To: T10 Technical Committee
From: Tim Symons, PMC-Sierra (Tim_Symons@pmc-sierra.com)
Date: 5 September 2008
Subject: 08-360r0 SAS-2 ZONE GROUP VALID bit

The purpose of the ZONE GROUP VALID bit needs to be clarified. sas2r14d does not define when this bit is set to one or set to zero.

Figure 56 – Zoning expander route table

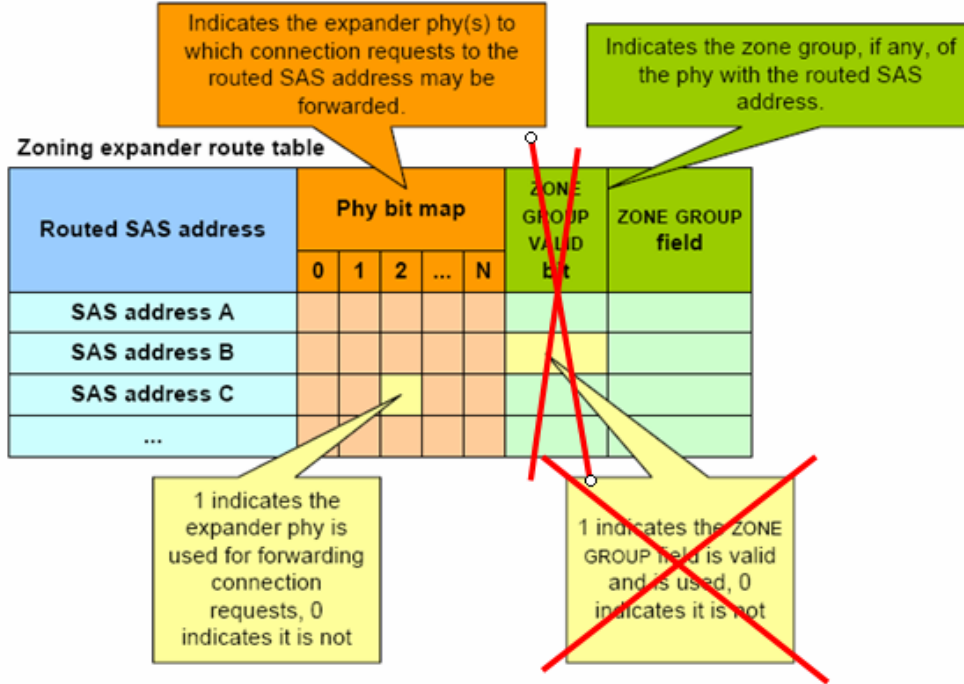
Other references for the ZONE GROUP VALID bit are in Figure 56 and Table 34 but both references are confusing and unnecessary.

Editors note : If zoning is enabled then the ZONE GROUP field is valid else it is not.
